VERSION HISTORY

FIRMWARE TPS/i - EN

1 CHANGES FROM V2.4.7 TO V2.4.8

Motor force monitoring

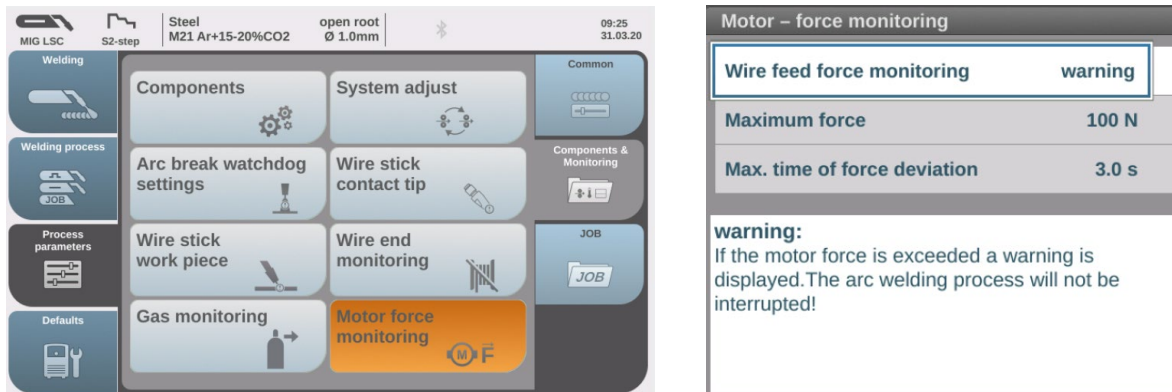
To get feedback about the wire feeding conditions (wear of the inner liner, wire feed motor,...) it is now possible to monitor the motor force. A specific reaction can be defined if the limit is exceeded.

Note: always the process relevant motor M1 is monitored.

A limit violation with setting “warning” will be displayed in the logbook of the SmartManager. It is necessary to add the column motor force.

New trigger mode for spot welding

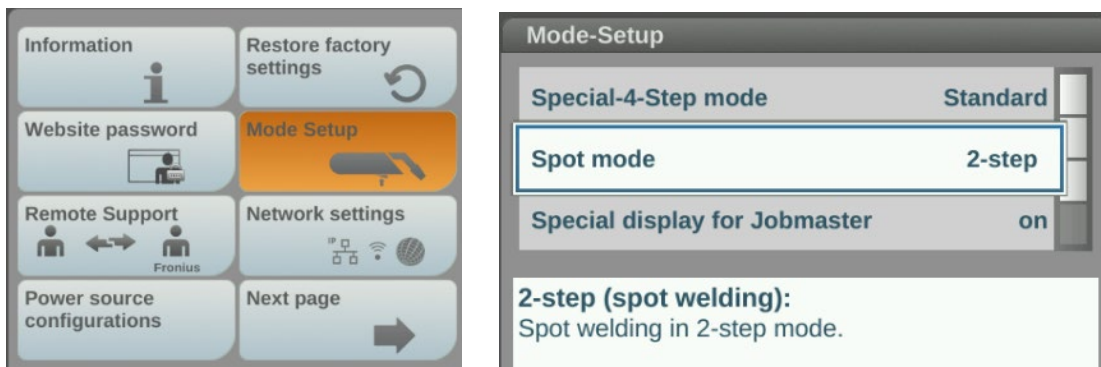
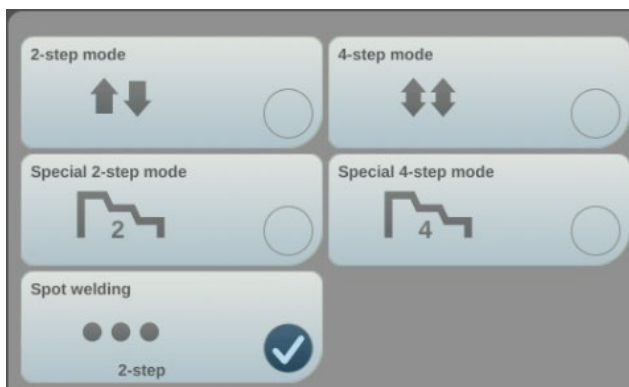
The trigger mode for spot welding can now be changed from the known 4-step mode to a 2-step mode. For critical welding applications, which are welded in spot mode, the weld can now be stopped at any time from the welder.

The actual setting for the spot welding trigger mode is as well visible in the trigger mode setting.

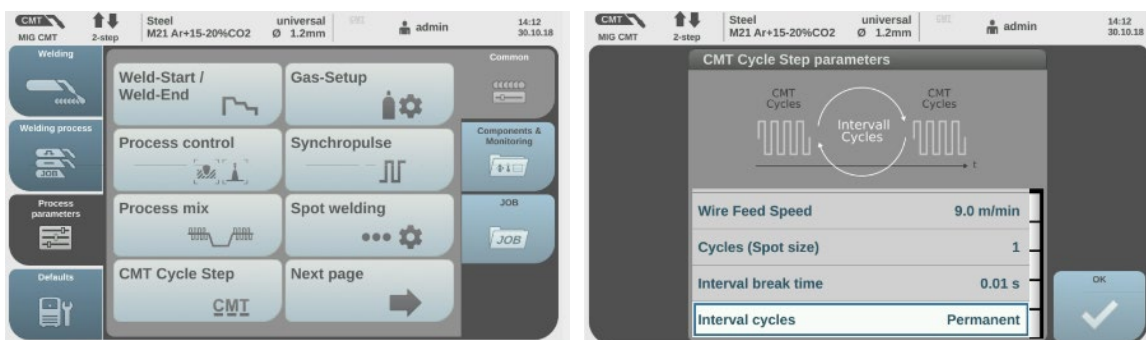
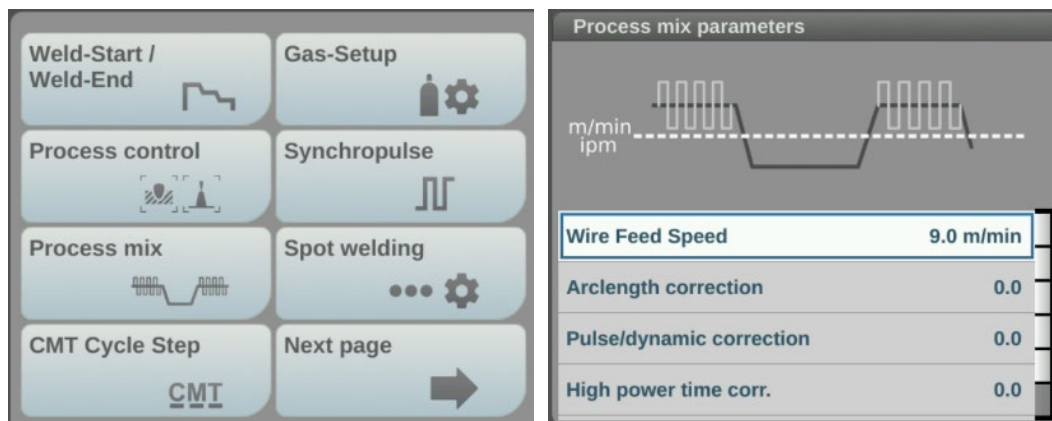
With OPT/i CMT Cycle Step it is possible to use the Cycle Step process for all CMT synergic lines.

Interval break time: 0,01 – 2 sec
 The interval break time is the time between each welding spot. A higher time allows the welding spot to cool down longer, the more defined is the seam appearance (ripples).

Interval cycles: Permanent/ 1 – 2000
 The number of repetitions of the CMT-cycles (incl. break time) till weld stop. If setting is on permanent the repetitions are ongoing until Arc Off (weld stop).

Enable / disable wire feeder potentiometer

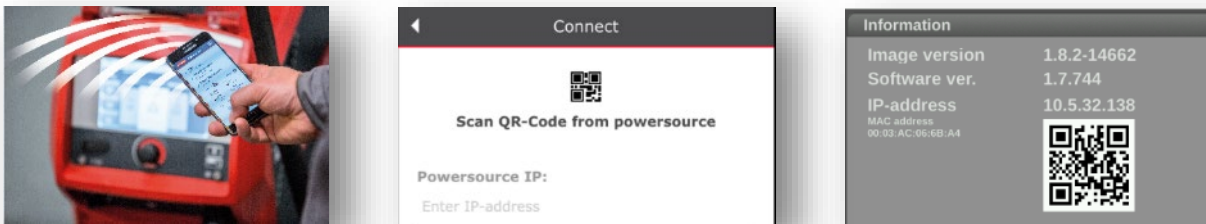
The potentiometers on the wire feeder can now be enabled or disabled on the power source.

Monitoring gas flow

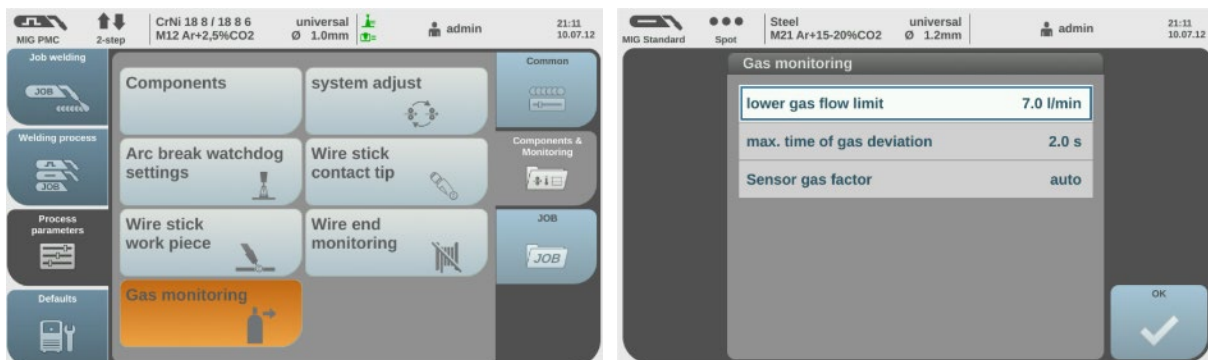
Required option: OPT/i gas flow sensor

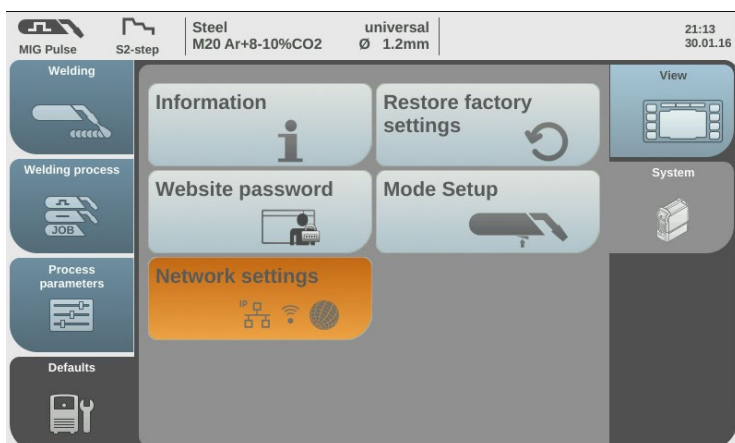
To avoid unwanted access or modifying welding parameters, it is now possible to lock the power source. The access control is contactless via NFC on the MCU (touch display) with a key card or a key fob.

The lock function will be active on all TPS/i power sources that have the symbol below.

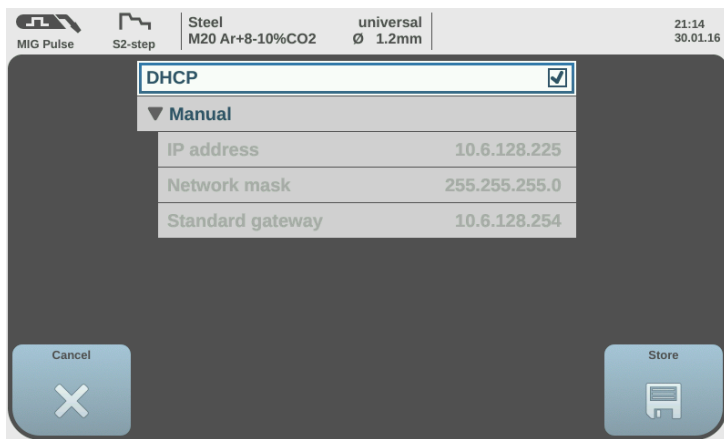
To simplify the implementation of the TPS/i in a network structure, it's now possible to set a static IP-Address for the Ethernet Port. This can be done directly on the touch screen through the set-up menus.

Default setting is DHCP – with this setting the IP address is dynamically assigned to the power source through the network.

Power limit activated

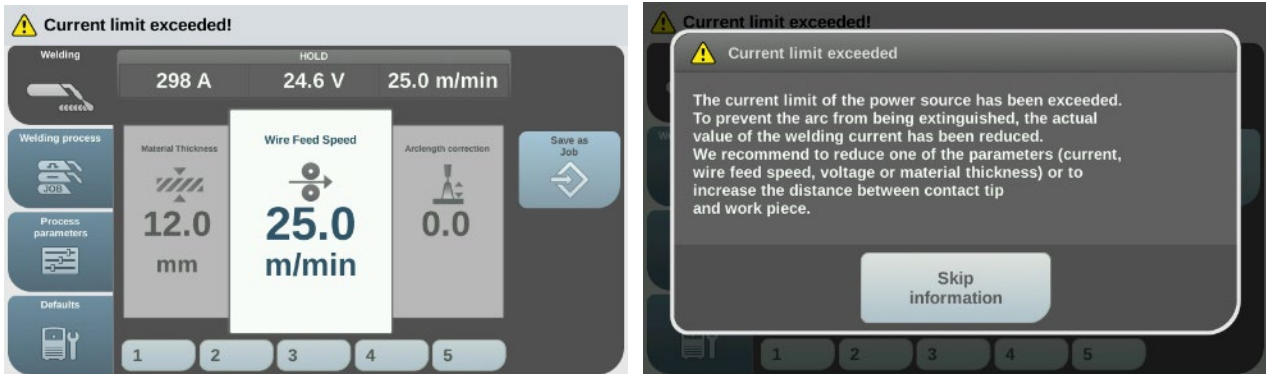
If a power source exceeds its current limit, the wire feed speed is automatically reduced. A hint is displayed in the status line. For more information an info window can be opened by touching on the status line.

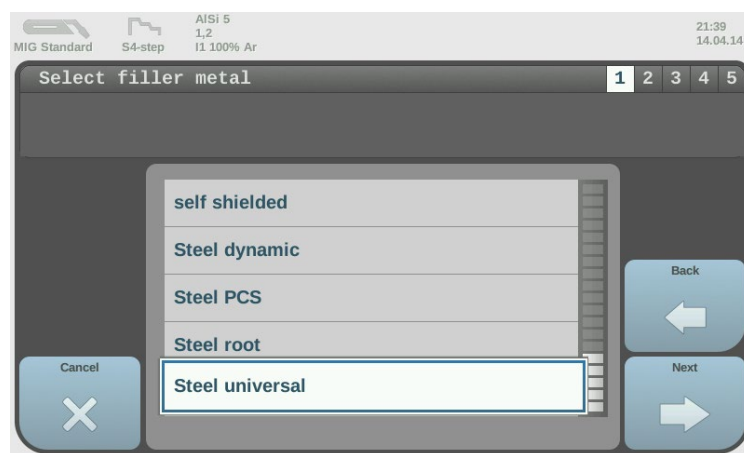
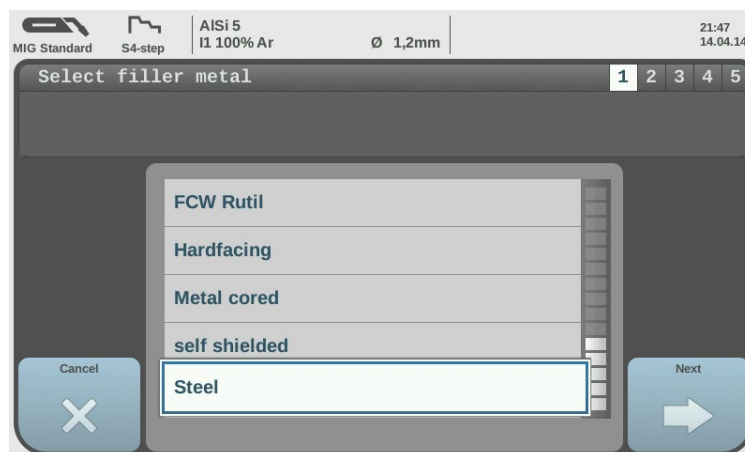
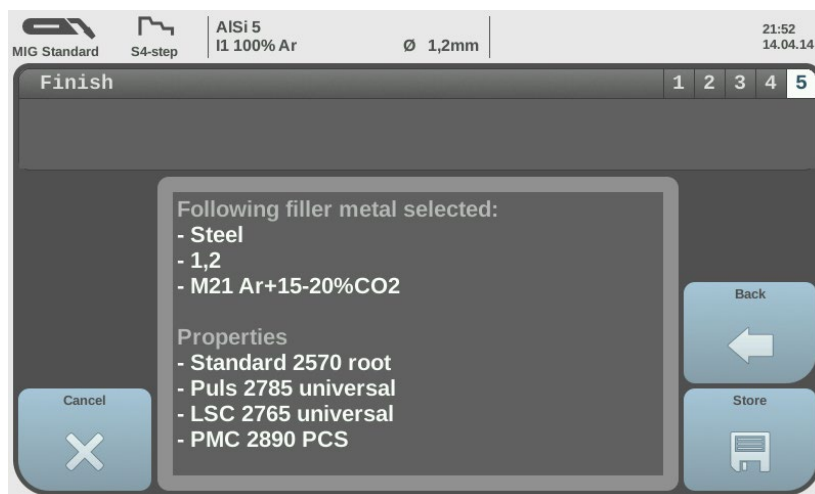
The structure of the material wizard was changed to multiple choice selections per welding process.

Previous display

Changes

Step 1: Filler metal selection – only the filler metal is displayed

Step4: selection of the available synergic line per process

Multiple synergic lines can be available per process. Select them via the rotary push potentiometer.

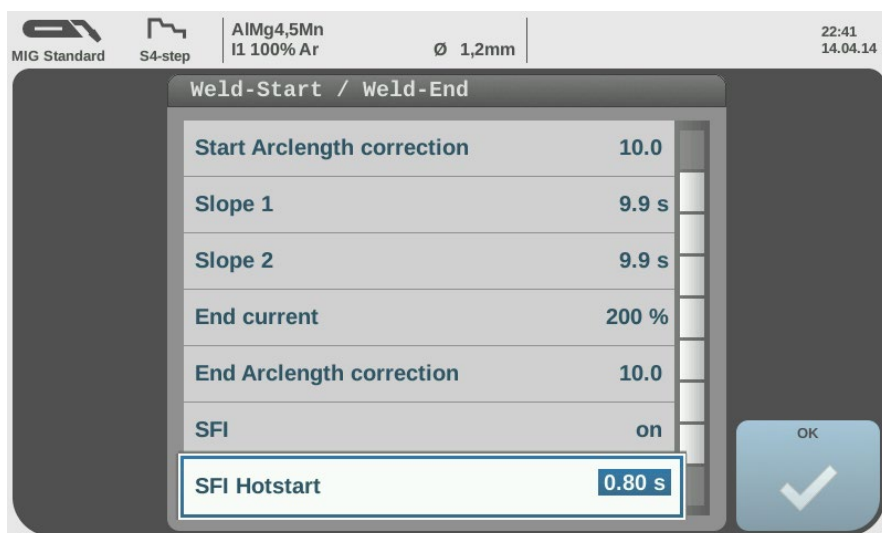
This parameter works only in combination with SFI ignition on PMC aluminum synergic lines.

A spray arc is set for the Hotstart duration during the SFI ignition. This ensures a higher heat input (independent of the trigger mode 2T/4T/S4T) and therefore a deeper penetration right from the welding start.

Effect of the “Arc length stabilizer”

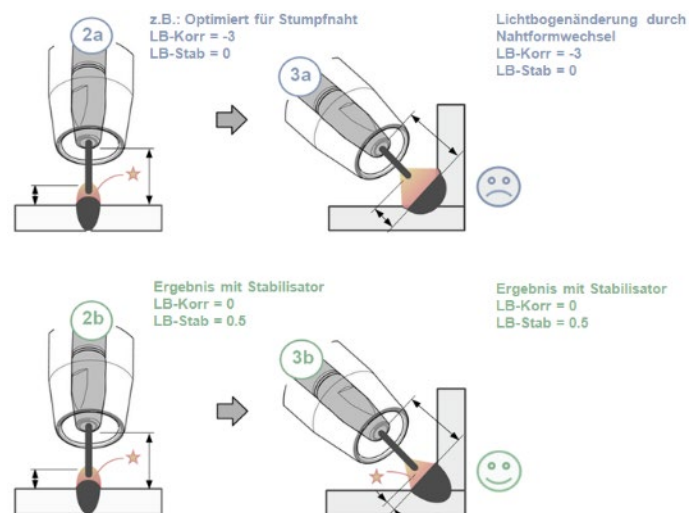
Independent of the welding position, the seam geometry or other influences, the welding characteristic of the short circuit regulated arc remain the same.
